Access Compliance Report

Public Rights-of-Way

Intersection ID: 32274	Main Street: MYERS_MILL_LN	Cross Street: WILLOUGHBY_RUN_DR	Location: SW
ADA ID: 334DF25FCF3E	Ramp Type: BlendTrans1	Initial Pass/Fail: Fail	Overall Compliance: No
Severity Score: 8.75			
Codes/Mitigation Info/Possible Solution		Field Measurements/Component Compliance

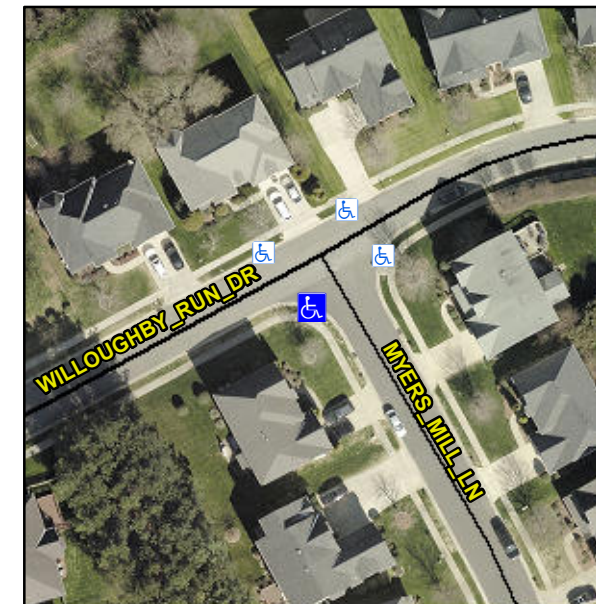
Not Found, R304.5.1

Compliance	Description	Data	Compliance	Description	Data
N/A	Ramp Length (in)	48.0	Yes	BlendTrans Slope (%)	4.6
No	Ramp Width (in)	38.0	Yes	BlendTrans XSlope (%)	1.2
N/A	Flare Type LT	N/A	N/A	Flare Type RT	N/A
N/A	Flare Slope LT (%)	N/A	N/A	Flare Slope RT (%)	N/A
N/A	Flare Traversable LT?	N/A	N/A	Flare Traversable RT?	N/A
N/A	Landing Length (in)	N/A	N/A	DWS Provided?	N/A
N/A	Landing Width (in)	N/A	N/A	DWS Contrast?	N/A
N/A	Landing Slope (%)	N/A	N/A	DWS Length (in)	N/A
N/A	Landing X Slope (%)	N/A	N/A	DWS Full Width?	N/A
N/A	Landing Curb? (Y/N)	N/A	N/A	DWS Offset (in)	N/A
N/A	Shared Landing?	N/A			
N/A	Gutter Ponding?	N/A	N/A	Gutter Slope (%)	N/A
N/A	Gutter Lip Ht (in)	N/A	N/A	Gutter X Slope (%)	N/A
N/A	Painted X Walk1?	No	N/A	Painted X Walk2?	No
	X Walk 1 Direction	To NE		X Walk 2 Direction	To NW
	X Walk 1 Width (in)	N/A		X Walk 2 Width (in)	N/A
	X Walk 1 Slope (%)	1.7		X Walk 2 Slope (%)	0.4
	X Walk 1 X Slope (%)	1.0		X Walk 2 X Slope (%)	1.4

N/A	Ramp inside XWalk1?	N/A	N/A	Ramp inside XWalk2?	N/A
	Road Slope (%)	0.6		Clear Space?	N/A
	Road X Slope (%)	0.1	N/A	Clear Space to XWalk (in)	N/A
N/A	Any Obstructions?	N/A	N/A	Storm Grate/Utility Hazard?	N/A
	Obstruction Type			Storm Grate/Utility Type	
		N/A			N/A
			Yes	Surface Condition? (G/P)	Good
			No	Curb Slope (%)	10.8

Remove & Replace Curb Ramp With Two New Directional Ramps or Equivalent.
